# *Technical Committee on Sprinkler System Discharge Criteria*

## MEMORANDUM

**SUBJECT:** **AUT-SSD AGENDA PACKAGE – A2012 ROC Meeting**

Enclosed is the agenda for the Report on Comments (ROC) meeting for NFPA 13, *Standard for the Installation of Sprinkler Systems*. NFPA 13 has entered the Annual 2012 revision cycle and will produce a 2013 Edition. It is imperative that you review the attached comments in advance and come to the ROC meeting with your ideas and substantiations for your views. If you have alternate suggestions for text changes, please come prepared with the words and respective substantiation.

Renumber existing (ROP) 17.2.1.4 as new 17.2.1.5.

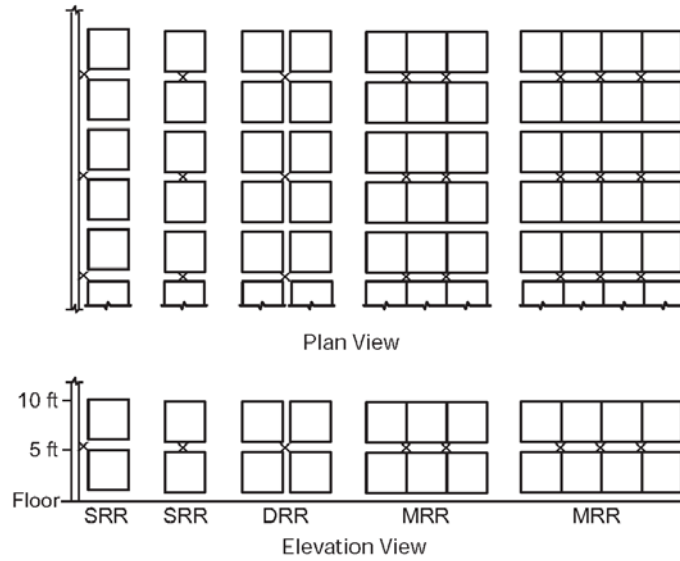
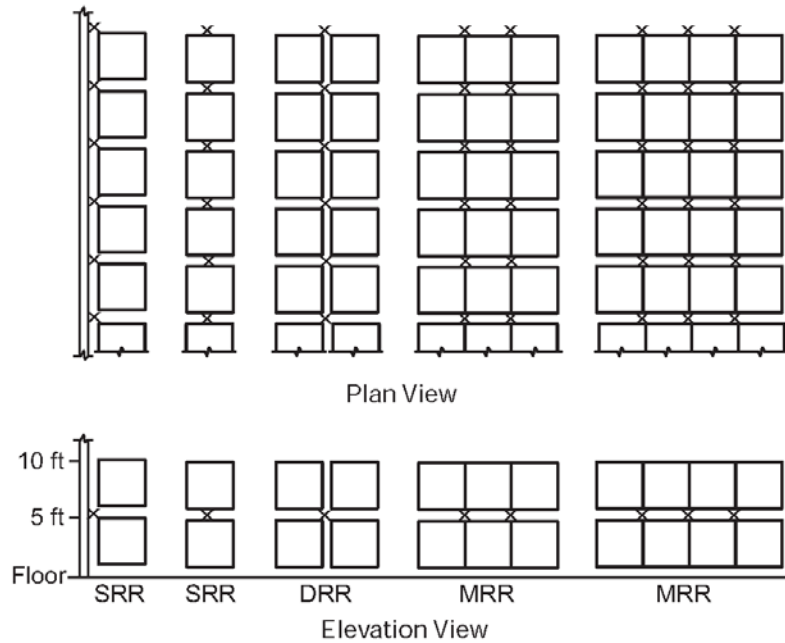
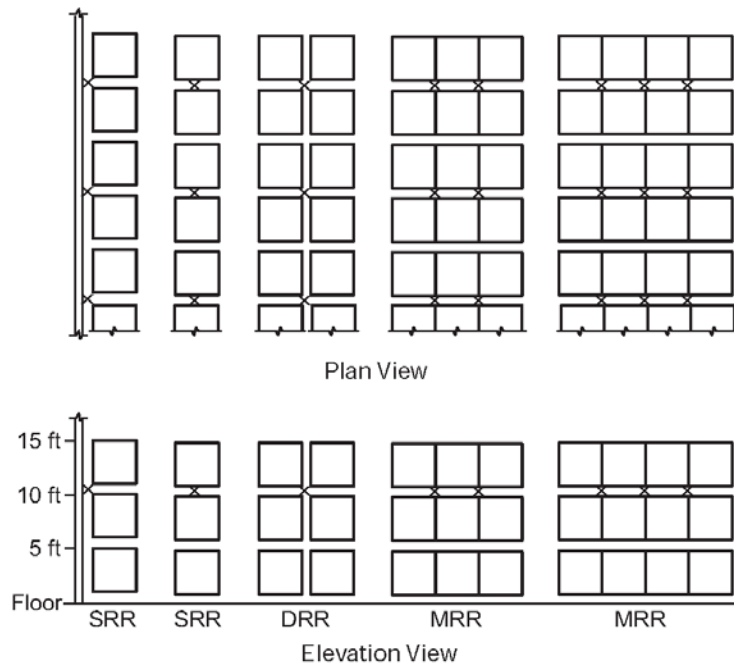
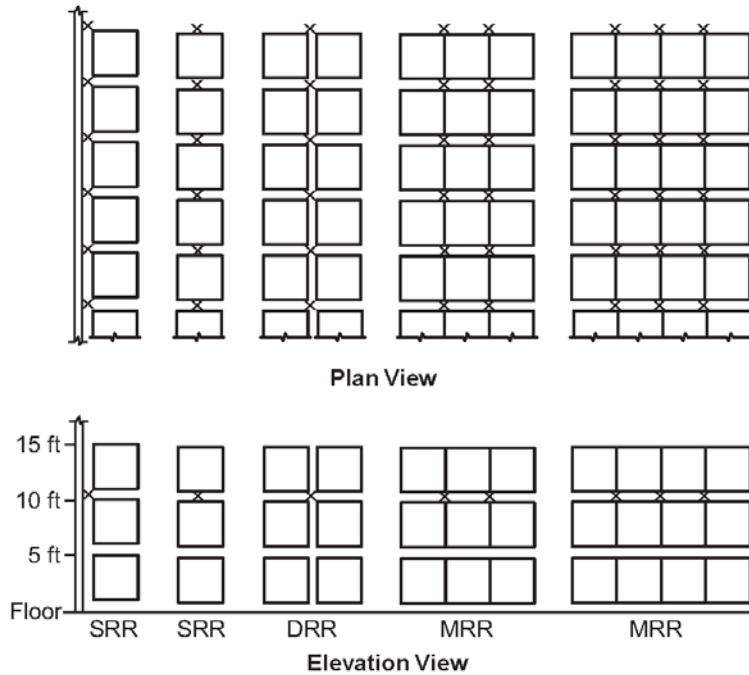
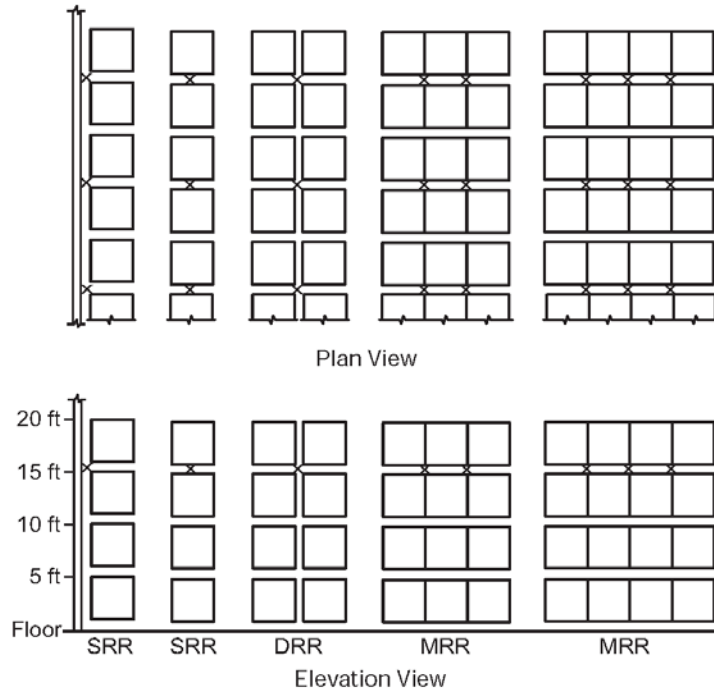
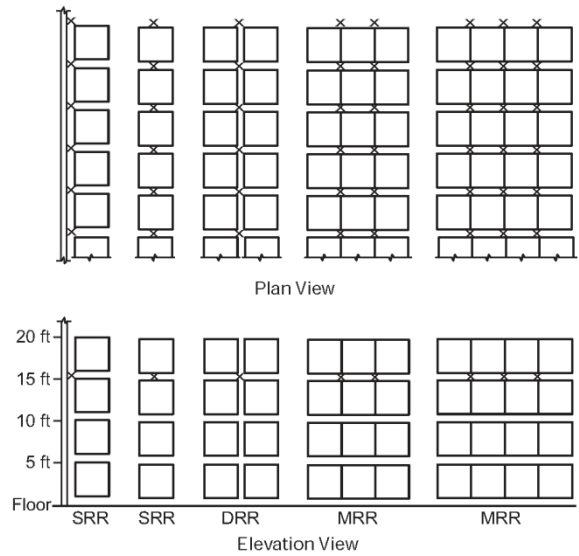
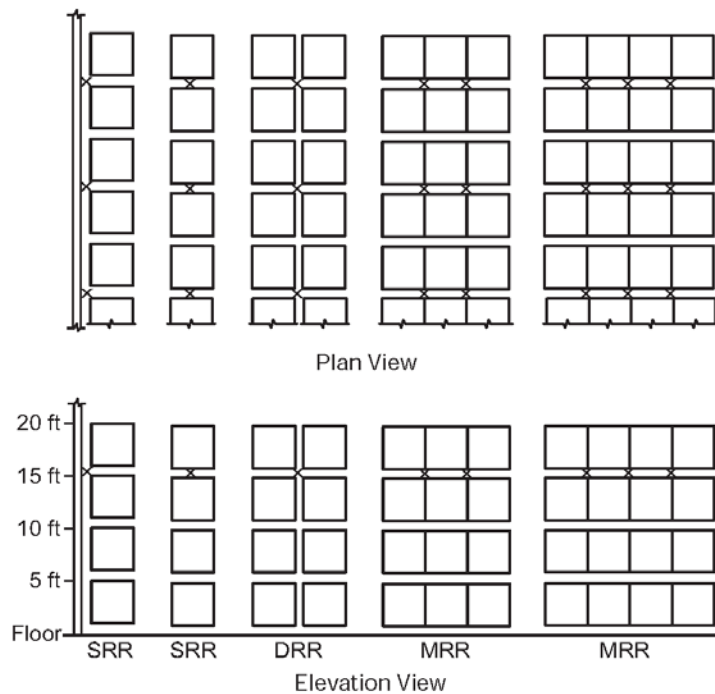
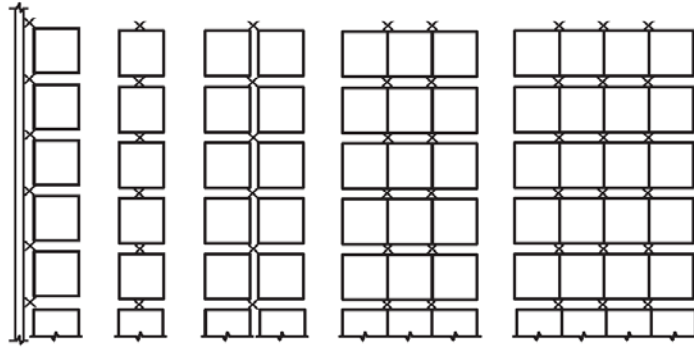
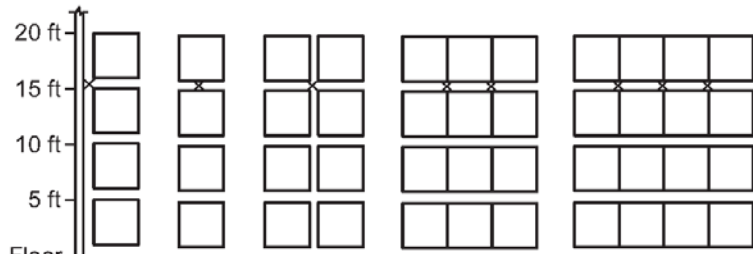
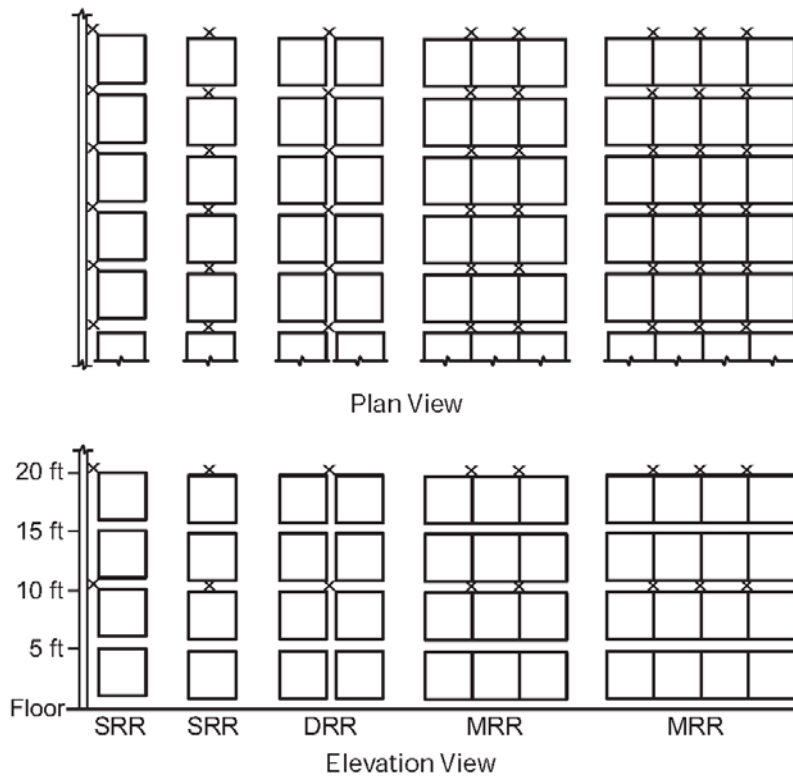
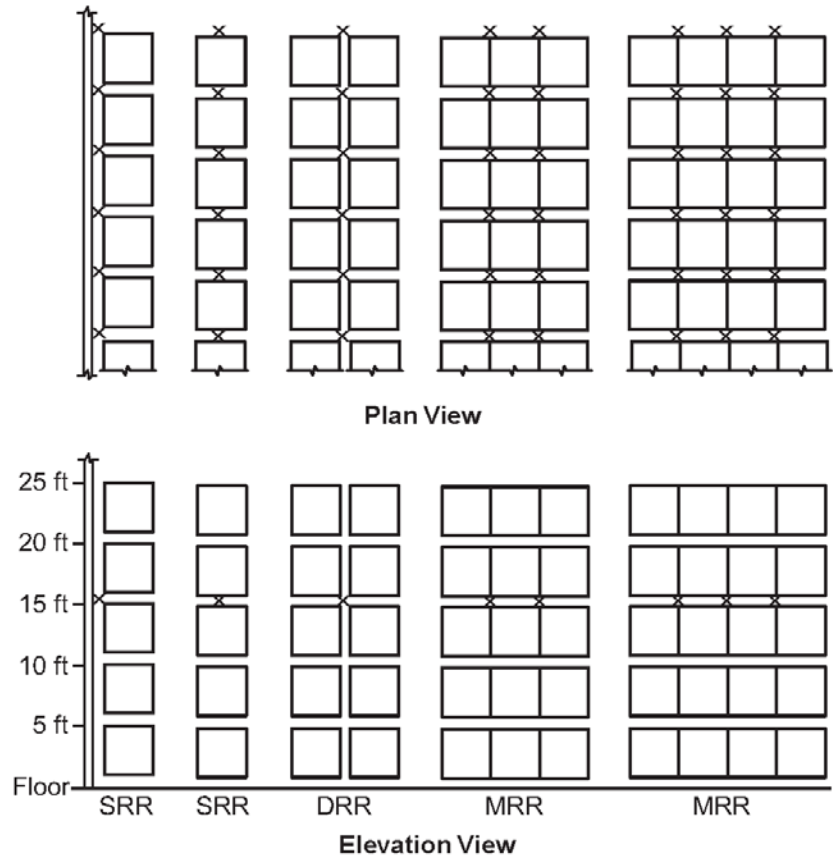
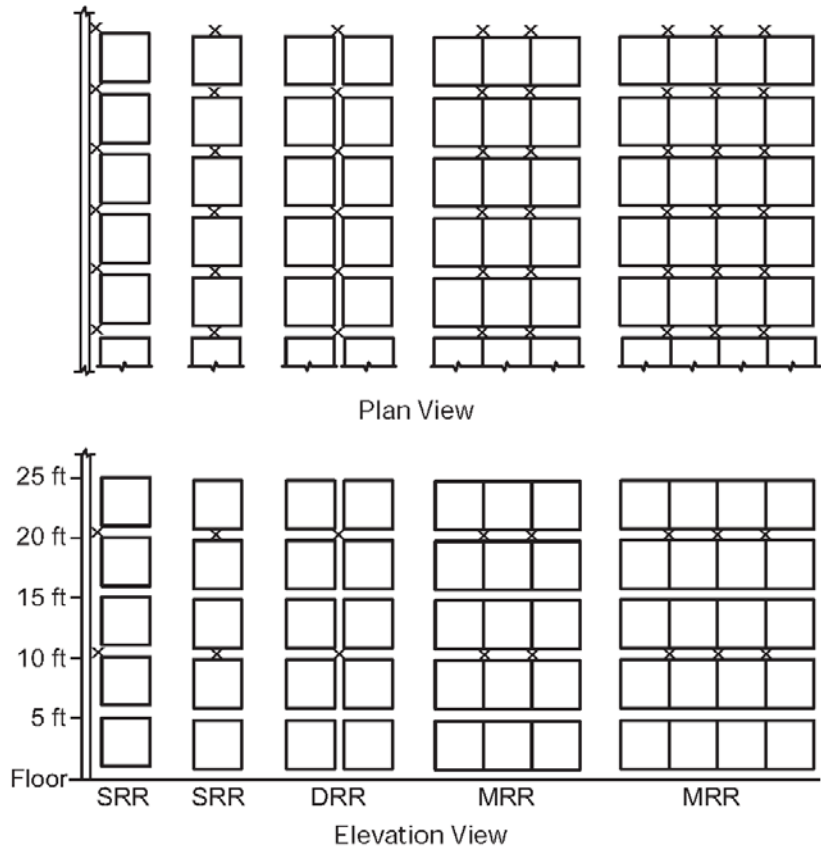
(a) Maximum 10 ft storage in a maximum 20 ft high building with ceiling sprinklers designed for a minimum 0.8 gpm per sq ft density over 2500 sq ft and no in-rack sprinklers required as shown in Figure 17.2.1.4(a).

(b) Maximum 10 ft storage in a maximum 20 ft high building with ceiling sprinklers designed for a minimum 0.45 gpm per sq ft density over 2000 sq ft and one level of in-rack sprinklers required at alternate transverse flues as shown in Figure 17.2.1.4(b).

(c) Maximum 10 ft storage in a maximum 20 ft high building with ceiling sprinklers designed for a minimum 0.3 gpm per sq ft density over 2000 sq ft and one level of in-rack sprinklers required in every transverse flue as shown in Figure 17.2.1.4(c).

(d) Maximum 15 ft storage in a maximum 25 ft high building with ceiling sprinklers designed for a minimum 0.45 gpm per sq ft density over 2000 sq ft and one level of in-rack sprinklers required at alternate transverse flues as shown in Figure 17.2.1.4(d).

(e) Maximum 15 ft storage in a maximum 25 ft high building with ceiling sprinklers designed for a minimum 0.3 gpm per sq ft density over 2000 sq ft and one level of in-rack sprinklers required in every transverse flue as shown in Figure 17.2.1.4(e).

(f) Maximum 20 ft storage in a maximum 25 ft high building with ceiling sprinklers designed for a minimum 0.6 gpm per sq ft density over 2000 sq ft and one level of in-rack sprinklers required at alternate transverse flues as shown in Figure 17.2.1.4(f).

(g) Maximum 20 ft storage in a maximum 25 ft high building with ceiling sprinklers designed for a minimum 0.45 gpm per sq ft density over 2000 sq ft and one level of in-rack sprinklers required in every transverse flue as shown in Figure 17.2.1.4(g).

(h) Maximum 20 ft storage in a maximum 30 ft high building with ceiling sprinklers designed for a minimum 0.8 gpm per sq ft density over 1500 sq ft and one level of in-rack sprinklers required at alternate transverse flues as shown in Figure 17.2.1.4(h).

(i) Maximum 20 ft storage in a maximum 30 ft high building with ceiling sprinklers designed for a minimum 0.6 gpm per sq ft density over 1500 sq ft and one level of in-rack sprinklers required in every transverse flue as shown in Figure 17.2.1.4(i).

(j) Maximum 20 ft storage in a maximum 30 ft high building with ceiling sprinklers designed for a minimum 0.3 gpm per sq ft density over 2000 sq ft and two levels of in-rack sprinklers required in every transverse flue as shown in Figure 17.2.1.4(j).

(k) Maximum 25 ft storage in a maximum 35 ft high building with ceiling sprinklers designed for a minimum 0.8 gpm per sq ft density over 1500 sq ft and one level of in-rack sprinklers required in every transverse flue as shown in Figure 17.2.1.4(k).

(l) Maximum 25 ft storage in a maximum 35 ft high building with ceiling sprinklers designed for a minimum 0.3 gpm per sq ft density over 2000 sq ft and two levels of in-rack sprinklers required in every transverse flue as shown in Figure 17.2.1.4(l).

**Substantiation:** This is mostly an editorial rewrite of the section as it was approved at the ROP for clarity. In addition, situations that resulted in a clearance greater than 10 ft were eliminated because they violated section 12.1.3.4.5.

Note, do we want to have operating areas of 1500 sq ft?
